Re: Leaning Juniper IIA Wind Power Facility – Amendment Determination Request

LEANING JUNIPER IIA WIND POWER FACILITY

AMENDMENT DETERMINATION REQUEST

DECEMBER 12, 2024

## Figure 3 Expanded laydown area - Turbine M3

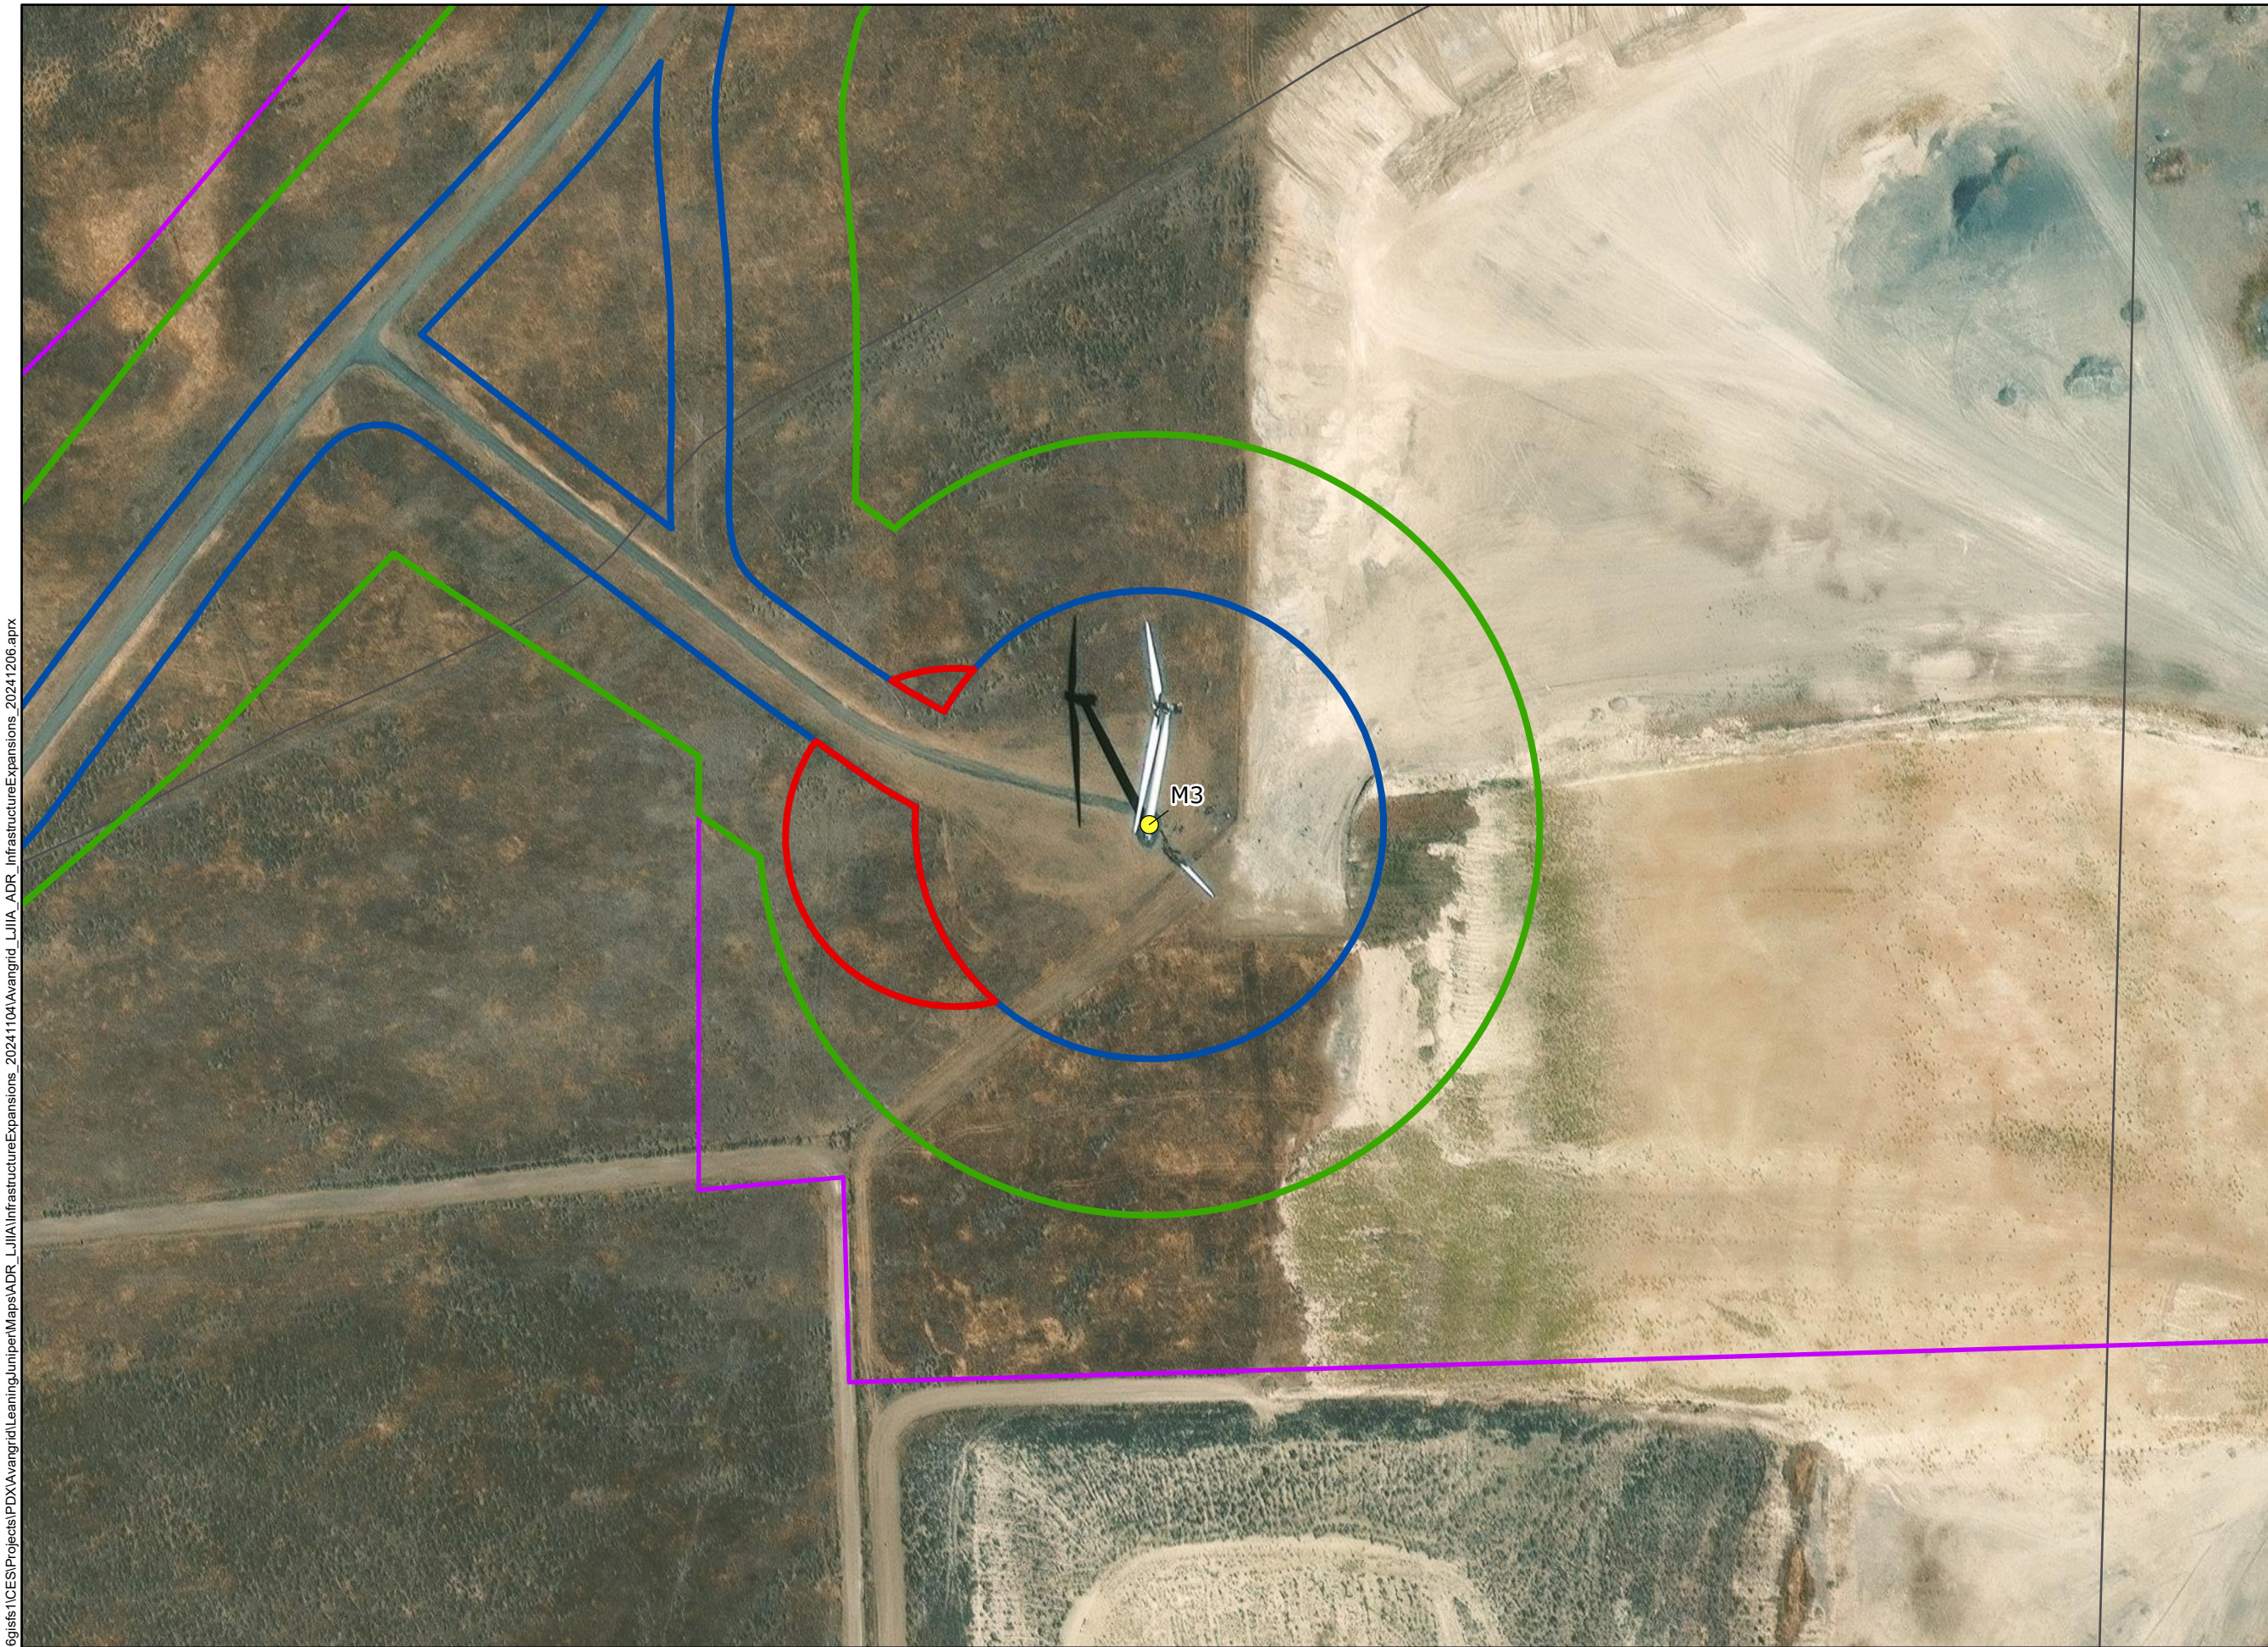
Certificate Holder plans to decommission two turbines (Turbine M3 and Z1) as part of the repower activities. In finalizing the decommissioning steps for the turbines, Certificate Holder has learned that the contractor will require a modified decommissioning work zone around the turbine to accommodate the dismantling activities.

The reason for the modified decommissioning method is because Turbine M3 experienced a fire and is not safe to be climbed for disassembly prior to decommissioning. The modified decommissioning approach will allow turbines to be decommissioned without walking cranes to these two sites, and will address safety hazards involved with decommissioning the turbine that burned in February of 2023. Certificate Holder proposes decommissioning Turbine Z1 using the same method because it will reduce the safety risk associated with turbine removal. Additionally, using this procedure will eliminate approximately 8,500 linear feet of crane walking distance, and 4

The modified decommissioning work zone is a shift in the shape of the estimated disturbance area at each turbine location described in RFA3 and would not result in an overall increase in the disturbance area for the repower effort. As described in the Site Certificate, the disturbance area at each turbine location consists of an area estimated as a circle with a radius of 275 feet around each turbine. As defined in RFA3, the disturbance area is intended to accommodate equipment storage and vehicle traffic, and areas may be graded and/or vegetation may be removed to allow repower activities. At the two locations where decommissioning will occur (Turbines M3 and Z1), an approximately 2-acre supplemental work zone for each turbine extending up to approximately 250 feet beyond the 275-foot radius in one direction will be needed in order to accommodate the modified decommissioning approach (see Figures 3 and 4). This supplemental work zone is where portions of the decommissioned turbine will fall. Portions of the approved circular disturbance area will still be used for vehicle traffic and limited equipment placement but for the two turbines that will be decommissioned, the disturbance area close to the turbine foundation will not need to be as large because no crane will be required and no new blades or components will need to be staged. No vegetation removal or grading is proposed for the modified work zones where they are more than 275 feet from the turbine. It is Certificate Holder's position that these decommissioning work zones do not amount to an increase in temporary disturbance under the Site Certificate and further that the total disturbance area for the repower will not exceed the area analyzed during the Council's review of RFA3.

## Figure 4 Expanded laydown area – Turbine Z1

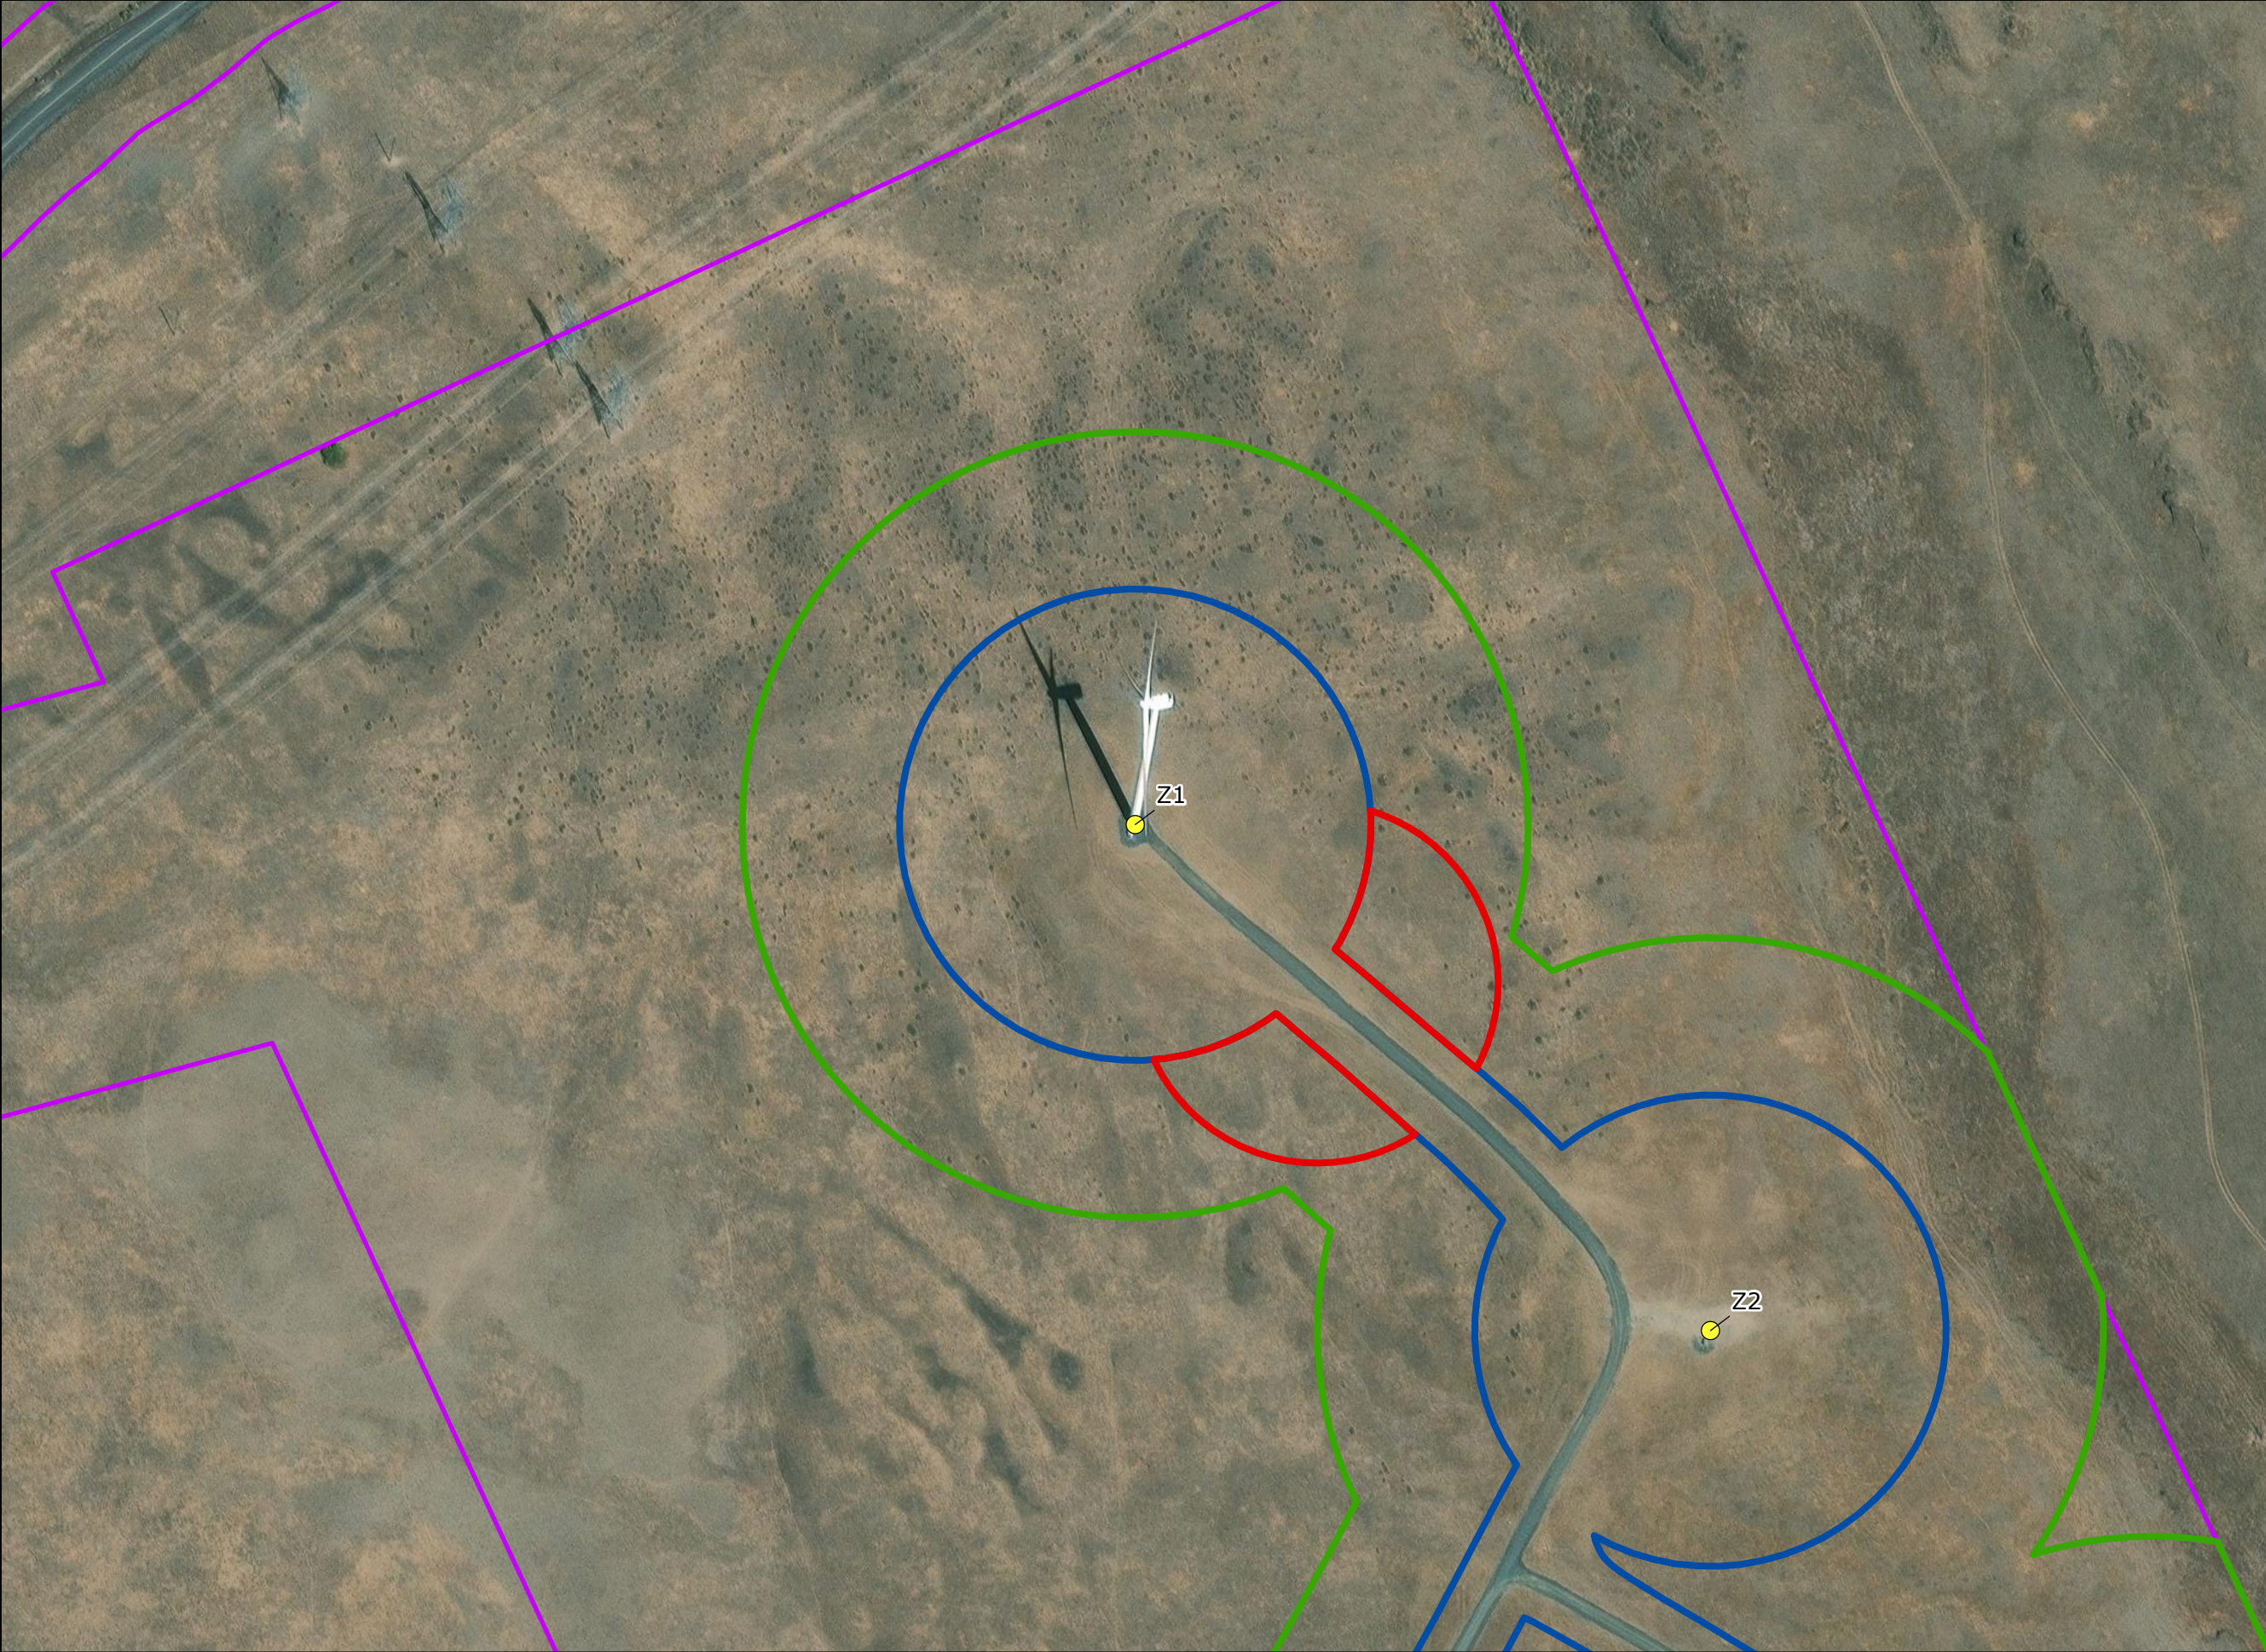
This supplemental work zone at these two turbine locations will not result in an overall increase in temporary disturbance associated with the repower action, but does result in activity outside of the maximum temporary disturbance specific to turbine pads as identified in Table 1 of the Site Certificate at these two locations (275 foot radius around turbine base). Table 1 is not a site certificate condition but it is part of the project description as presented in the site certificate.

## Figure 5 LJIIA Operations and Maintenance Facility Storage Yard Expansion

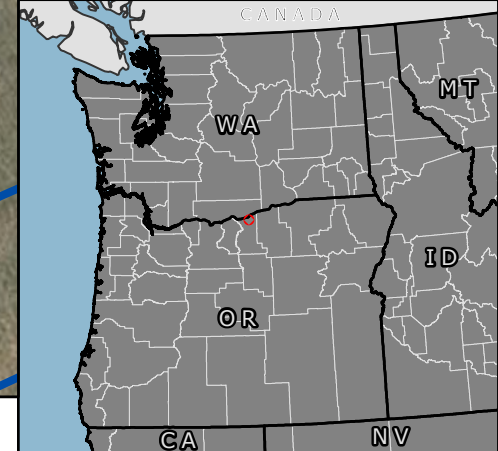
The Facility was previously approved for an O&M building with approximately 2.0 acres of fenced, graveled parking and storage area<sup>1</sup>. As constructed, the building itself occupies approximately 0.2 acre and is surrounded by approximately 1 acre of fenced, graveled parking and storage area. To improve facility operational flexibility following completion of the repower activity, Certificate Holder proposes to expand the existing storage area by approximately 1 acre, for a total of 2 acres of fenced, graveled storage and parking. See Figure 5.

This expanded storage area would occupy an area that was approved as part of Amendment 3 for laydown area. Instead of reclaiming this portion of the graveled laydown area following the repower effort, the area would be fenced and retained for operational use. The area has been fully surveyed for all resources and no new significant impacts would occur; however, one acre of land currently categorized as Category 3 Rabbitbrush-Snakeweed-Eriogonum/bunchgrass (SSA) would be permanently disturbed instead of temporarily disturbed. Mitigation for impacts to this habitat type were identified in the Final Order on Amendment #1 (EFSC 2009, Attachment C) at a ratio of 1 acre of mitigation for each 1 acre of impact. Because this land was already planned for mitigation at 0.5:1 ratio for temporary impacts, this would result in a net increase of 0.5 acre beyond the previously anticipated total. The Draft Habitat Mitigation Plan will be finalized as part of pre-construction compliance and this additional 0.5-acre requirement can be included with no new analysis or other new or modified site certificate conditions.
